UNITED STATES PATENT AND TRADEMARK OFFICE

APPLICATION NO.	FILING DATE	FIRST NAMED INVENTOR	ATTORNEY DOCKET NO.	CONFIRMATION NO.
10/788,624	02/27/2004	Troy L. Cooper	17319	6525

Office Action Summary

Claims 1-3,5-7 are rejected under 35 U.S.C. 103(a) as being unpatentable over Bauer et al. (523,508) in view of Bucknam (1,663,239).

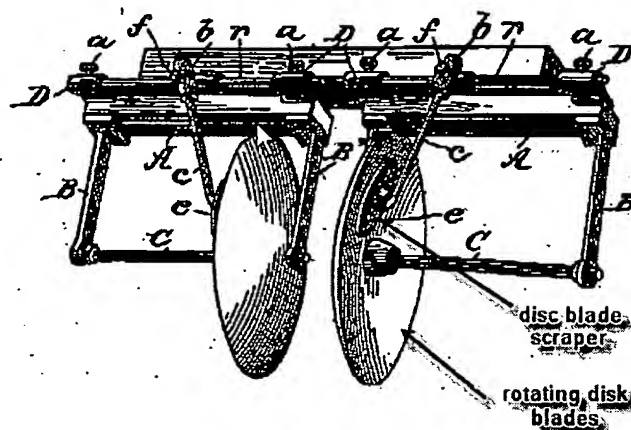
Bauer et al. discloses a disk blade scraper having a bracket (c) connected to the frame and a rotating disk (e) mounted to the bracket and having an axis of rotation and a circumference parallel to the axis of rotation. The bracket is connected to the frame and the rotating disk is mounted to the bracket such that the circumferential edge of the rotating disk is adjacent the transition joint of the disk (intersection of disks and shaft C). Bauer et al., however lacks showing the rotating disk blade including an annular depression relative to the concave surface, surrounding the transition joint.

Bucknam teaches that a disk blade including an annular depression surrounding the transition joint is an equivalent structure known in the art. Therefore, because these two disk blades were art-recognized equivalents at the time the invention was made, one of ordinary skill in the art would have found it obvious to substitute the disk blades of Bucknam for the disk blades of Bauer et al..

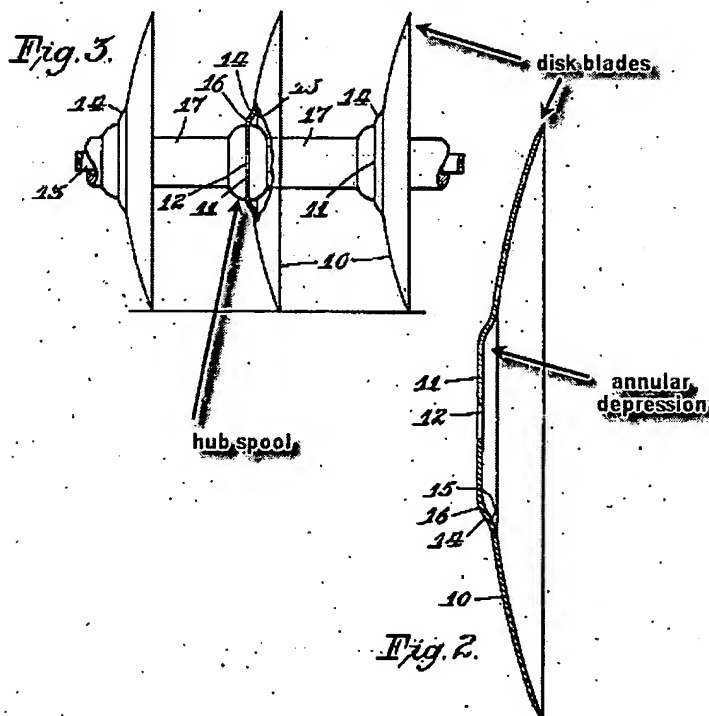
Bucknam discloses a tillage implement including rotating disk blades arranged in laterally spaced relationship on a shaft, including a hub spool, transition joint and an annular depression. Bucknam however lacks a rotating disk blade scraper.

Bauer et al. teaches that it is known in the art to use a disk blade scraper with a tillage implement to keep the disk blades clean.

It would have been obvious to one of ordinary skill in the art at the time the invention was made to modify the device of Bucknam with rotating disk blade scrapers mounted to a bracket connected to a frame as taught by Bauer et al., to keep the disk blades of Bucknam clean.
